## REMARKS

This response is being submitted in response to the Notice of Non-Compliant Amendment. It is otherwise identical to the applicants' response submitted March 27, 2008 save for the alleged omission to delete the presence of numeral "4". Notwithstanding that this response is identical to the response submitted March 27, 2008, applicants respectfully submit that the alleged instance of non-compliance is erroneous. Applicants, in the prior submission of March 27, 2008, did use the "strikethrough" font utility provided in MS WORD® text editing program using "Times New Roman" character size 12. to indicate deletion of the phrase ~~according to Claim 4~~. Unfortunately, the strikethrough feature of such a font and character size strike's through the horizontal segment in the numeral "4" thus appearing that it is not "struck" through, i.e., (when in fact, it was, to wit: 4). To remove any ambiguity as to the intent of the Applicants amendment to Claim 7, applicants submit this new response with Claim 7 amended to show double brackets (e.g., [[4]]) indicating positive intent to delete the numeral.

In the Office Action of December 28, 2007, the Examiner first objected to the draw

With respect to the 35 U.S.C. §112, first paragraph rejection of Claim 7 applicants provide a simple illustration below labeled drawing “A” detailing, for the Examiner’s edification, the origin of the 90-degree meta-stable state:

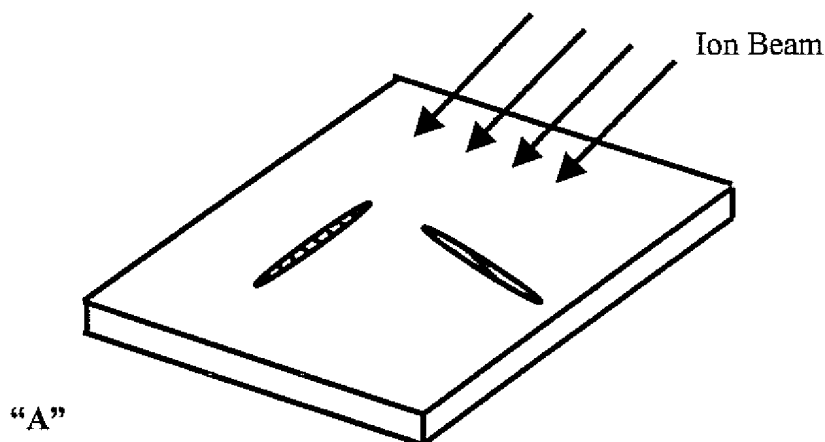
Further in the Office Action, the Examiner rejected Claims 2-11 and 18 under 35 U.S.C. §112, first paragraph, as allegedly failing to comply with the written description requirement. The Examiner particularly took issue with the last clause of Claim 4 (“aligning molecules parallel to the alignment direction of the second substrate”), and, the recitation of Claim 5 including a “second substrate aligned opposite the first substrate to include a top alignment layer having a grooved surface profile”.

This drawing particularly illustrates for the Examiner how, on a “flat” alignment layer or substrate surface with IB beam alignment, molecule 301 and 302 have same potential energy; and that, as shown in proposed new Fig. 6, the LC molecule 301 which is sitting inside the groove has a lower potential energy than molecule 302 that is sitting on the ridge of the groove. The grooved structure increase anchoring energy by reducing the potential energy of the molecules when they are situated along the groove. The recitation in rejected Claim 7 is directed to this concept of reducing the potential energy of the molecules when they are situated along the groove with full support in the specification as filed and the new proposed drawing figures illustrating the embodiment of Claim 7 having a flat surface profile for the “second” (top) substrate.

In view of the foregoing, Applicants respectfully submit that the recitations relied upon in the rejection of Claims 5 and 7, as amended, are a result of the methodology described herein and illustrated, particularly in new proposed Fig. 6 and the additional drawing “A” provided for the Examiner’s edification, and additionally, when gleaned from the paragraphs ¶[0022] and ¶[0023] of the originally filed specification.
